8 January 2021  
Case Number: ABP -308358-20  
Planning Authority Reference number: EC15-20

**Re:** Whether a garage/store to the side and single storey extension to the rear of house is or is not development or is or is not exempted development.  
39 Kylemore, School House Road, Castletroy, Co. Limerick

Views of drawing ref 17-76-002 and 17-76-004 showing distance between boundary wall and windows to be 900mm

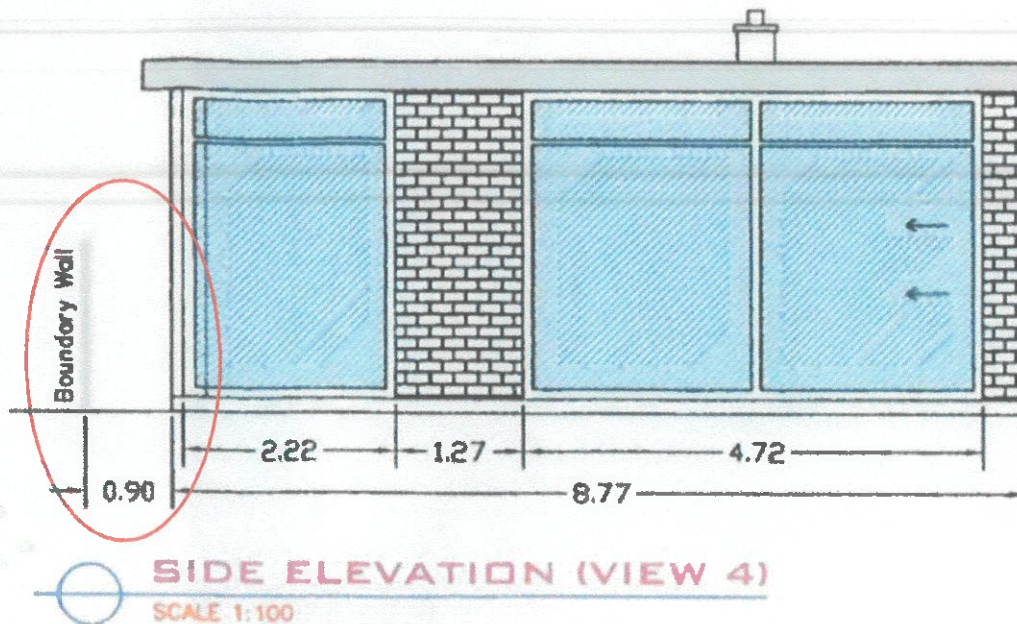
2. Notwithstanding the fact that a privacy shield is mentioned to be provided to the windows. The 'windows' on the boundary wall are still non the less, 'windows' and do not comply with paragraph 6(a) of the above-mentioned schedule of the regulations, i.e. they are windows that are less than 1m from the boundary it faces. The south/rear corner windows of the annex are 0.9m to the boundary wall. The corner returning windows on the south east elevation also are within 1 meter of the boundary wall (refer to applicant's site layout and elevation drawings ref 17-76-002 and 17-76-004 submitted to Limerick City and County Council on the 18-7-2017).

- The distance indicated from the rear wall of the annex to the rear boundary is indicated at 1.03m on the submitted Section 5 site plan. It was however indicated on the retention planning application drawings on both the floor plan and site layout plan as being 900mm (reference Planning Drawing no's 17-76-002 and 17-76-004). We are at a loss to understand how this dimension can change between the two applications in an established structure/ site. Clarification on this ambiguity is clearly required here for the reasons as highlighted above.
